1992 - Oahu - FEIS -  
Fort Derussy

**FINAL**

**ENVIRONMENTAL IMPACT STATEMENT**

**DEVELOPMENT OF THE  
ARMED FORCES RECREATION CENTER -  
FORT DERUSSY, WAIKIKI, HAWAII**

FIGURE  
 II-2

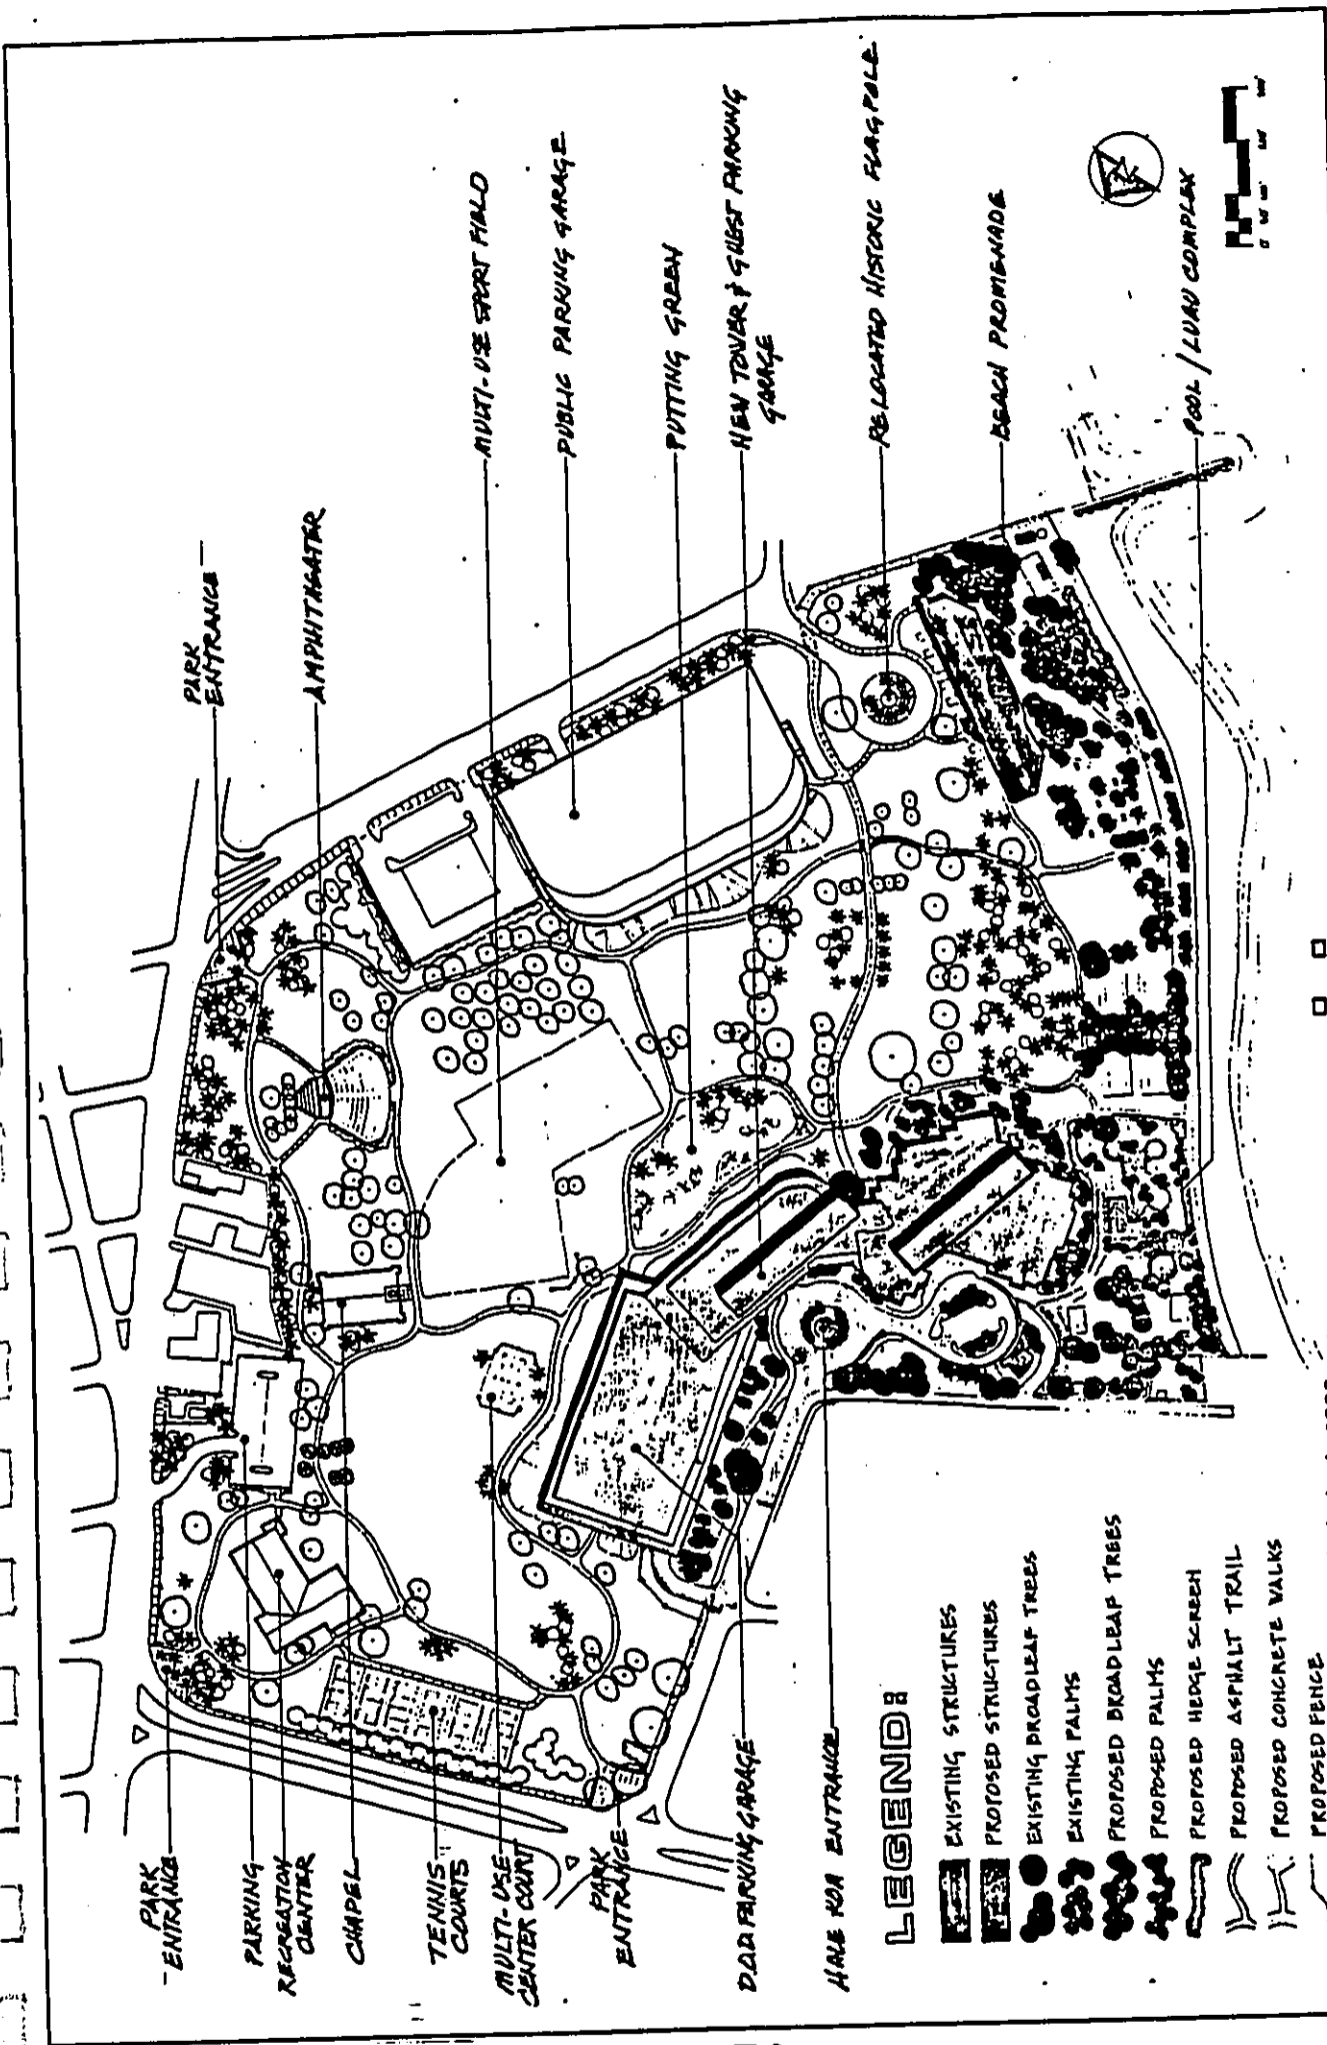
4. Alternative B-1 proposes the same development scheme as the proposed action with the exception of leaving Kalia Road as a two-lane facility. This Alternative B-1 best meets the objectives of the Waikiki Special District (WSD) if the terraced parking structures in Alternative B-2, as shown in Figure II-2, are incorporated into Alternative B-1. (DLU)

FIGURE  
 II-2

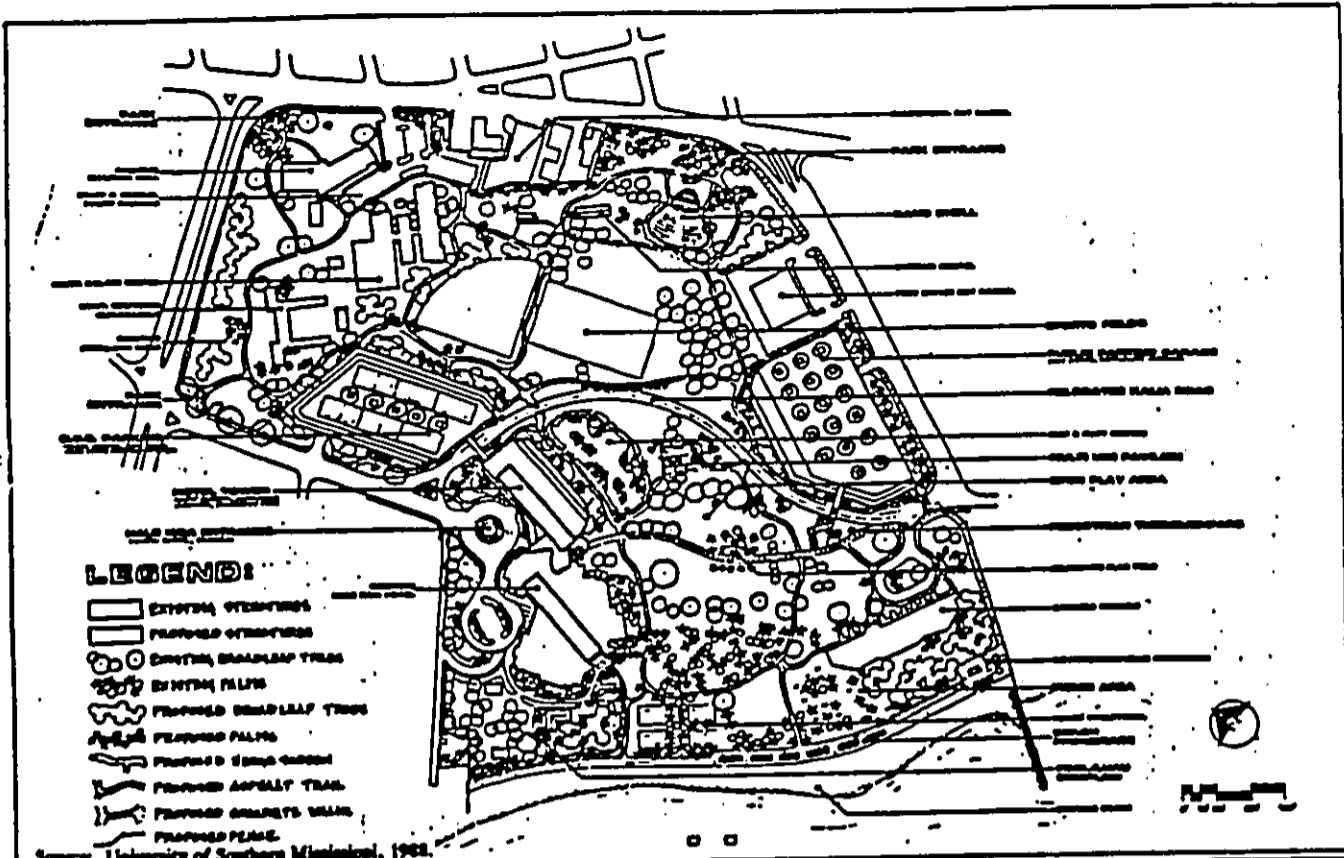
The proposed realignment of Kalia Road as shown in Figure II-1 of the Fort DeRussy Armed Forces Recreation Center Conceptual Master Plan would significantly impede our postal operations at the Waikiki Station Post Office. It would also create serious traffic and customer service problems for our businesses, residents and visitors in Waikiki.

The attached sketch (portion of Figure II-1) provided by your staff shows that our present exit-driveway on Saratoga Road is to be blocked, and that the customer vehicular traffic would be routed through our parking lot and mail unloading/loading area to the realigned Kalia Road. This would not only eliminate 27 parking stalls but also create a dangerous mix of postal and customer vehicles. Our 5- and 7-ton trucks make seven interstation runs each day, together with our delivery vehicles and the hundreds of customer automobiles would cause severe traffic congestion in our lot and create serious safety problems. The security of our postal vehicles and building is another of our concern.

It is hereby requested that the proposed Kalia Road realignment other than as shown on Figure II-1 be considered. Alternative B-2 (Figure II-2) or other options should be given consideration.
